Access Compliance Report Public Rights-of-Way (Curb Ramps)

Intersection ID: 52800 Main Street: CHARMECK_PALISADES_DR Cross Street: CARNEGIE_BV Location: SE **Overall Compliance: No** ADA ID: 1491249382A6 Ramp Type: Directional1 Initial Pass/Fail: Fail **Severity Score:** 25

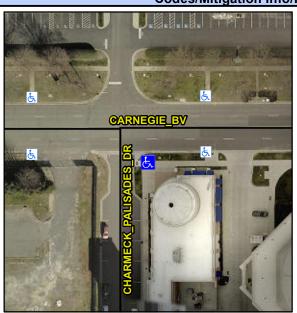
Possible Solutions: Remove & Replace Entire Ramp. Surveyor Notes: N/A PROW/ADA: R304.2.2, R304.5.3

Field Measurements/Component Compliance								
Compli	ance Description	Data	Compl	iance Description	Data			
N/A	Ramp Length (in)	69.0	N/A	Grade Break?	N/A			
Yes	Ramp Width (in)	63.0	N/A	Grade Break Slope (%)	0.0			
No	Ramp Slope (%)	9.5	N/A	Grade Break XSlope (%)	0.0			
No	Ramp XSlope (%)	5.8						
N/A	Flare Type LT	N/A	N/A	Flare Type RT	N/A			
N/A	Flare Slope LT (%)	N/A	N/A	Flare Slope RT (%)	0.0			
N/A	Flare Traversable LT?	N/A	N/A	Flare Traversable RT?	N/A			
N/A	Landing Length (in)	0.0	N/A	DWS Provided?	N/A			
N/A	Landing Width (in)	0.0	N/A	DWS Contrast?	N/A			
N/A	Landing Slope (%)	0.0	N/A	DWS Length (in)	N/A			
N/A	Landing X Slope (%)	0.0	N/A	DWS Full Width?	N/A			
N/A	Landing Curb? (Y/N)	N/A	N/A	DWS Offset LT (in)	N/A			
N/A	Shared Landing?	N/A	N/A	DWS Offset RT (in)	N/A			
N/A	Gutter Ponding?	0.0	N/A	Gutter Slope (%)	N/A			
N/A	Gutter Lip Ht (in)	0.0	N/A	Gutter X Slope (%)	N/A			
N/A	Painted X Walk1?	No		Road Slope (%)	0.7
